Vario2 IPPoE 2.5 – Updated Features

Issue g

05-10-20

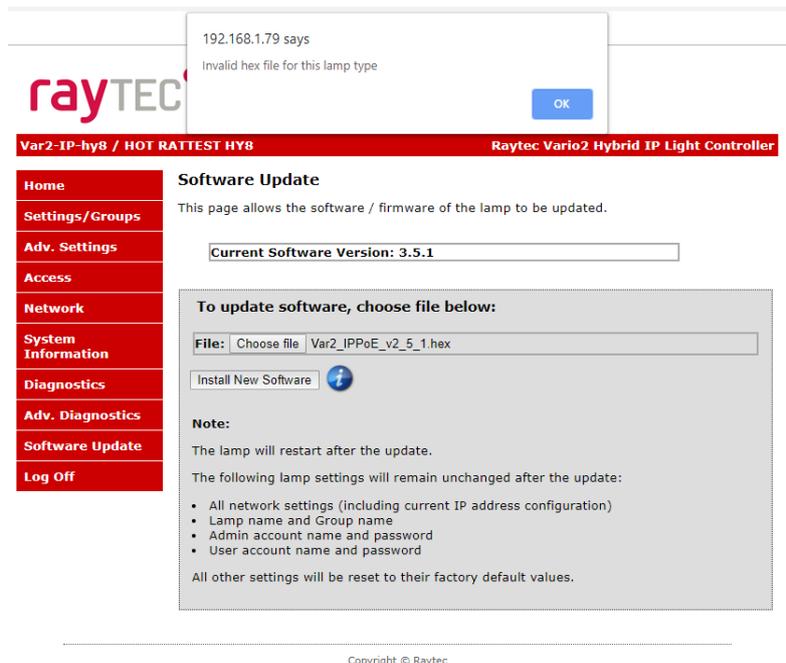
Vario2 IPPoE 2.5 adds a check when upgrading the illuminator's firmware to ensure that the firmware that is about to be loaded is the correct one for the illuminator.

For example, on a single wavelength Vario2 IPPoE 2.5 illuminator, the web page is looking for the name *Var2_IPPoE_v*.hex* where * is a version number e.g. *Var2_IPPoE_v2_1_3.hex*, *Var2_IPPoE_v2_5_0.hex*.

On a Hybrid illuminator, the check is for *Hybrid_IPPoE_v*.hex*. Again, * is the version number check e.g. *Hybrid_IPPoE_v3_1_2.hex*, *Hybrid_IPPoE_v3_5_0.hex*.

If you tried to load Hybrid software onto a non Hybrid illuminator or non Hybrid software onto a Hybrid illuminator you will be prevented from doing so and get an invalid file message.

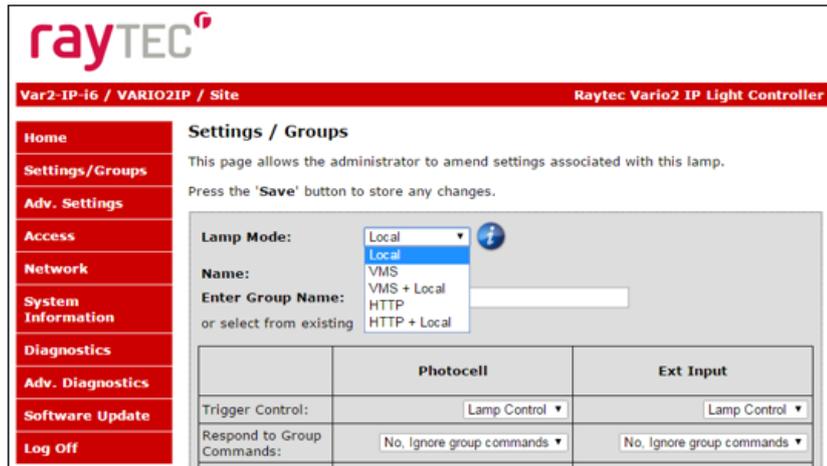
Raytec has added a new diagnostic feature in Vario2 IPPoE 2.5 firmware, the Black Box Recorder. The illuminator now records how long the illuminator has been powered up for, how long the LEDs have been on for and the maximum voltage the illuminator has seen over the lifetime of the illuminator.

This can be found on the *Diagnostics* web page of the illuminator web interface:

Note : Maximum voltage recorded is PoE or DC whichever is the higher

Note : Recording starts after a maximum of 5 minutes from power on.

(This is to prevent power on at the factory during standard production testing being recorded on the black box recorder)
